Opposition LOC 2020 - 0063

Opposition – LOC 2020 – 0063

Concerns:

3.1 On-Street Parking

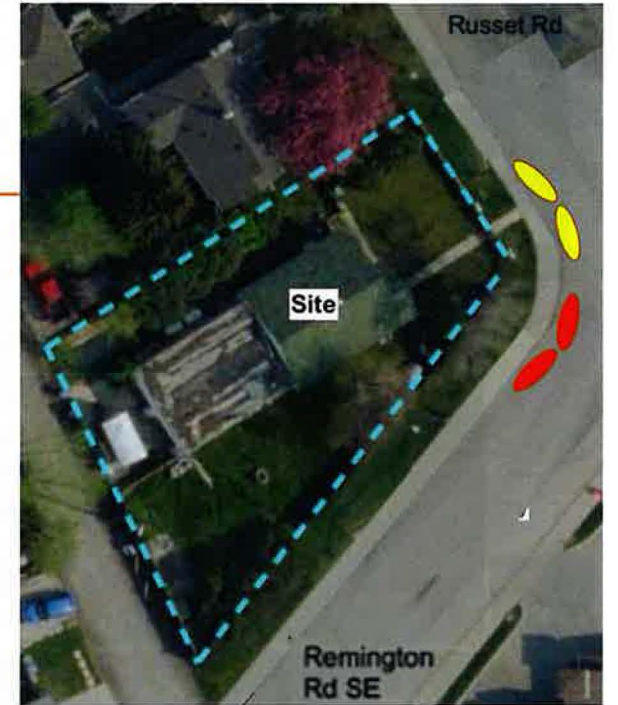
Ignores the intersection work (curb bump outs)

Implies people should park unsafely

Implies that seven vehicles are possible around this lot

Intersection work removes one stall from Russet (currently in-place yellow concrete curb bump outs) – future work will remove one stall from Remington (future red concrete curb bump outs)

Vehicles cannot park within 1.5m from a laneway and 5m from an intersection (Calgary Parking Authority)

Current daily parking only has three vehicles parked around the site, one on Russet and two on Remington, like most corner lots in Calgary

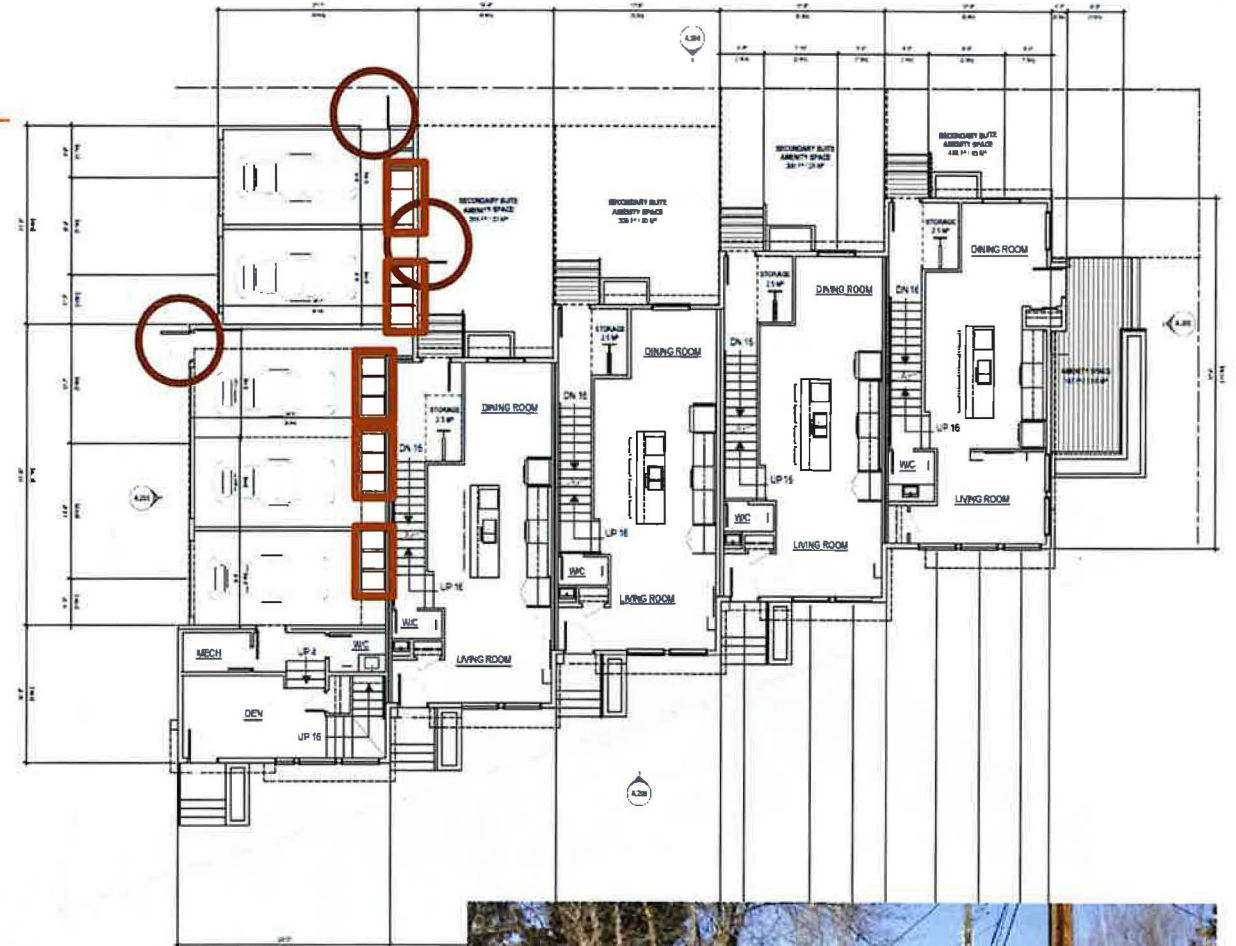
It has already been established that joint collection is not an option (Molok or similar)

The stated purpose of this development is a nine-unit, rental complex

With basement suite renters proposed to utilize the Blue, Black, Green Carts of the above-grade renters

Supposedly providing renters access to private garages?

Fifteen carts (27 if during DP it is deemed they need to be separate) will be in the laneway

1 MAIN FLOOR PLAN
SCALE: 1/8" = 1'-0"

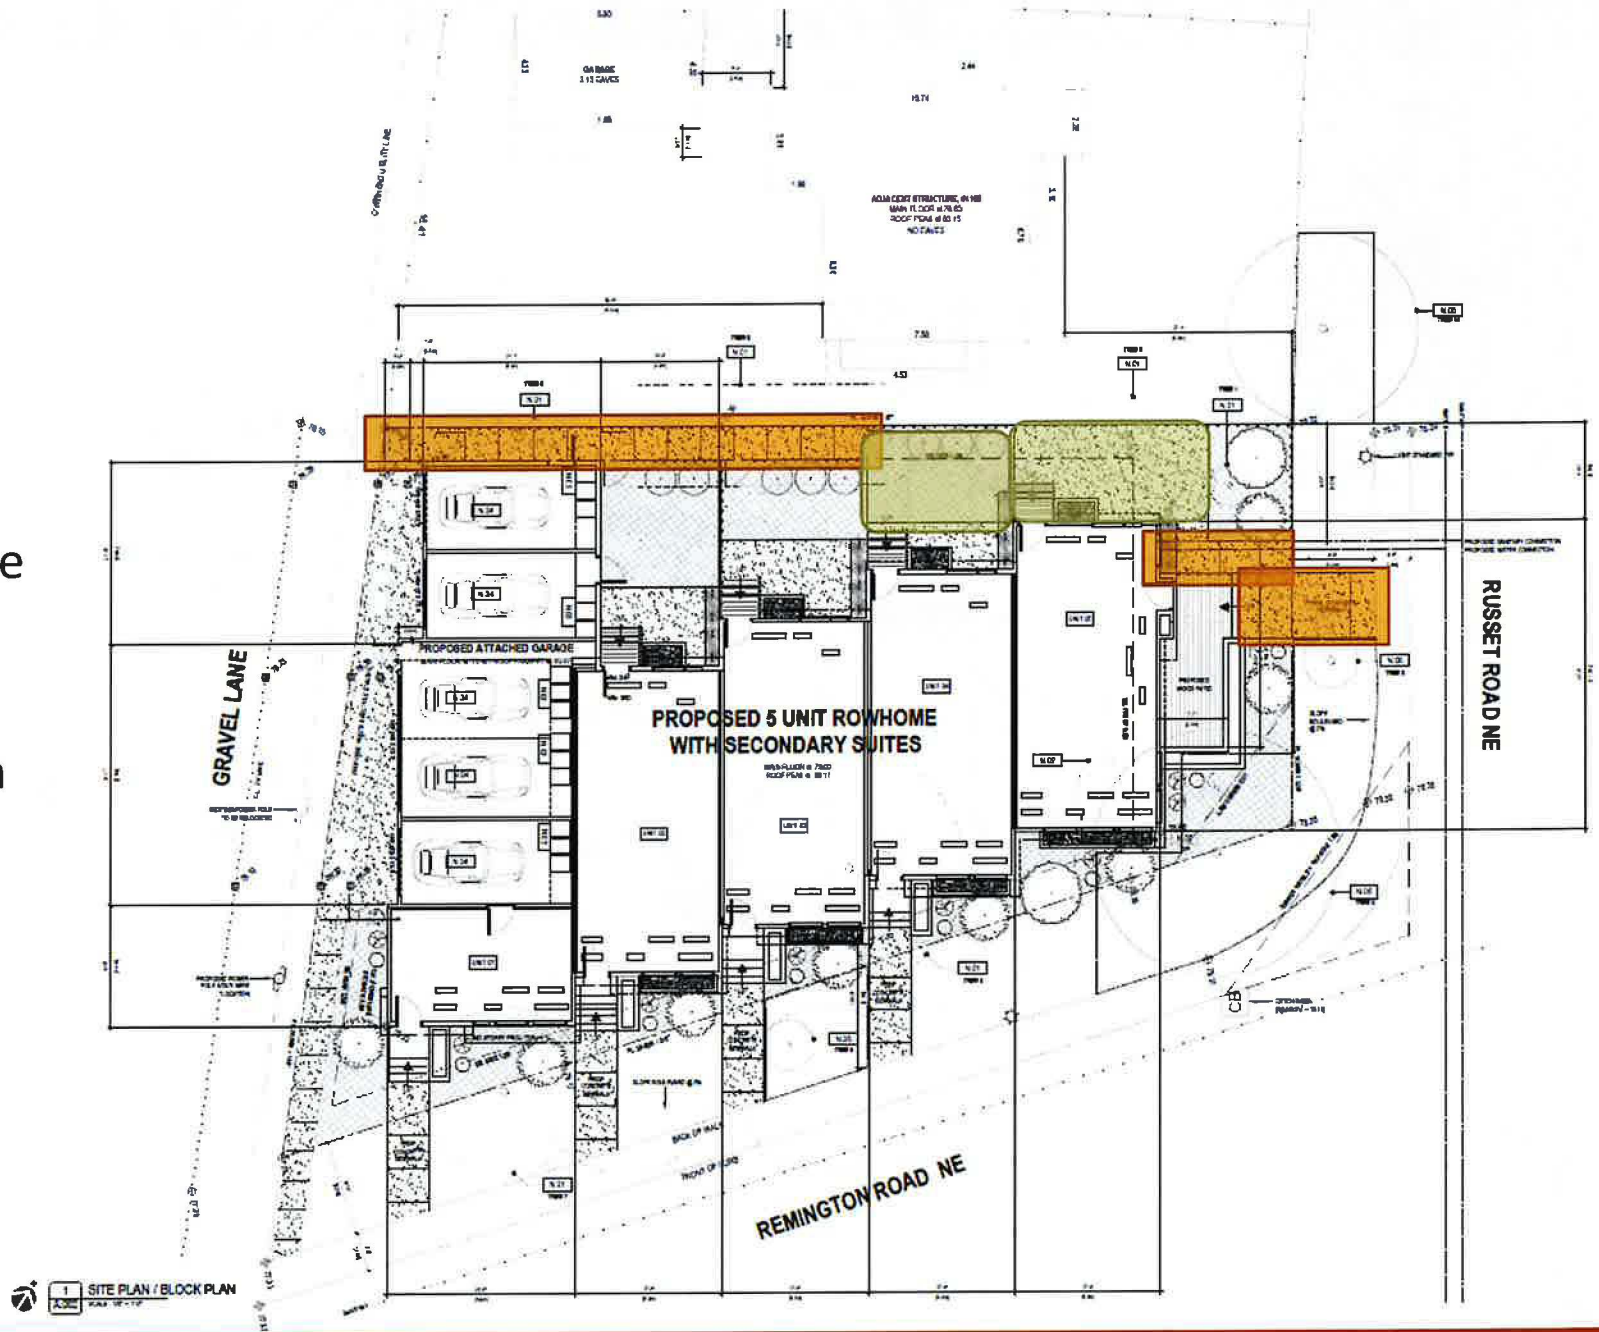
The LOC/DP creates a *public walkway* between my property and the development

Likely they wanted to extend it fully, cutting the two properties apart, but without the break, the minimum *amenity space* requirements are not met

The majority of Rowhouses with basement suites have suite entrances on major roads (not alleys / blind corners)

Route
19 Bus
Stop

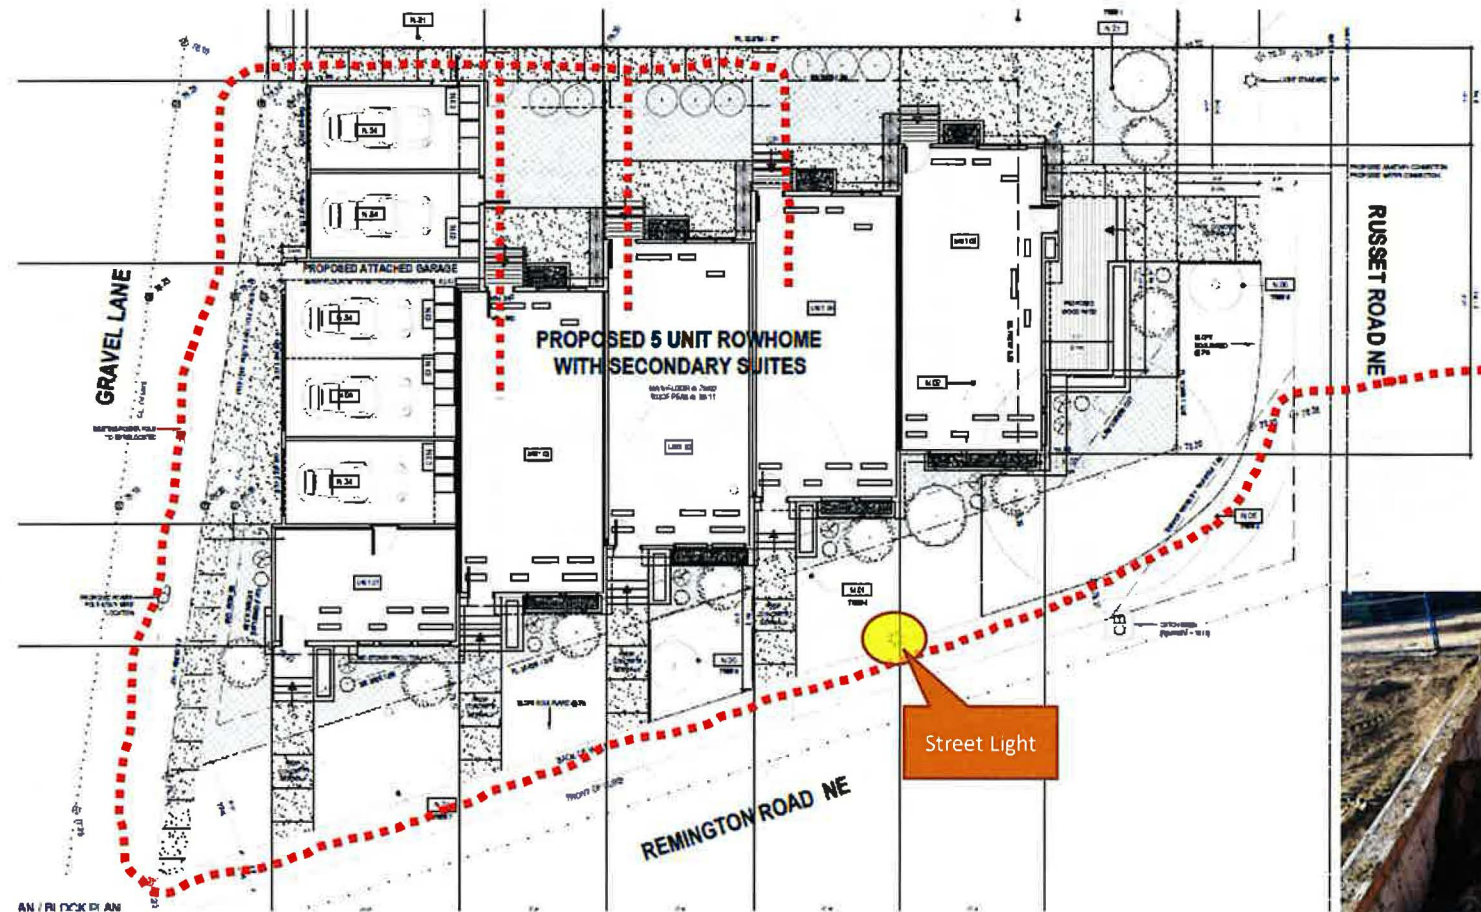
The design of this Rowhouse, with the only entrances for three units in the rear, is unsafe for renters

A basement-suite renter, hypothetically would get off the bus, cross the street, walk down Remington, turn into a laneway (alley), walk 100' down the alley, turn into a blind corner and down a dark narrow path

This strikes me as dangerous, alleys are not lit and people don't shovel alleys. They are dark and icy half the year. I also believe that this design creates the opportunity for a potential assault

Frequently there are transient people in the alley
